Item Name: Replacement Skidtube, Low Gear with Run-on Landing Fits LH or RH

TITLE SKIDTUBE ASSEMBLY, 206A/B
SCALE NTS

DRAWING NO. D3804	TITLE SKIDTUBE ASSEMBLIES, 206A/B	REV. A	DART AEROSPACE LTD ENGINEERING ORDER		D.E.O. NO. D3804-A-1	SHEET NO. SHEET 1 OF 1	SCALE NTS
DRAWN <i>CP</i>	CHECKED <i>A.P.</i>	MFG. APPR. <i>[Signature]</i>	APPROVED <i>[Signature]</i>	DE APPR. <i>[Signature]</i>			
DATE 12.10.12	DATE 12.10.22	DATE 12.10.22	DATE 12.10.22	DATE 12.10.22

CHANGE C'BORED WELDED CROSSBOLT SPACERS TO SWAGED SPACERS

WAS:

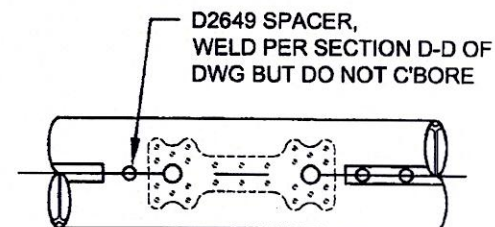
19	20	D2649	CROSS BOLT SPACER
----	----	-------	-------------------

AMENDMENT TO DETAIL B
NOT TO SCALE

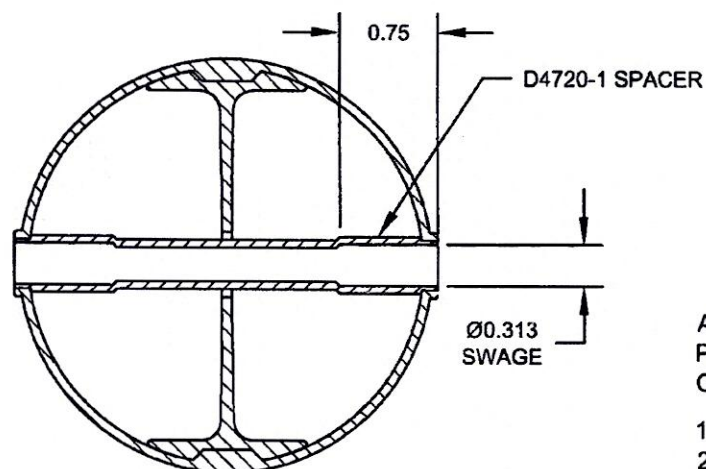
ADD SECTION H-H BELOW, WHICH IS THE SAME SECTION VIEW AS SECTION D-D OF DWG.
C'BORED HOLES ARE **NOW SWAGED** PER SECTION H-H BELOW. FOR THE Ø0.375 HOLE THAT IS NOT C'BORED, WELD PER SECTION D-D OF DWG (SEE AMENDED DETAIL B FOR REFERENCE).
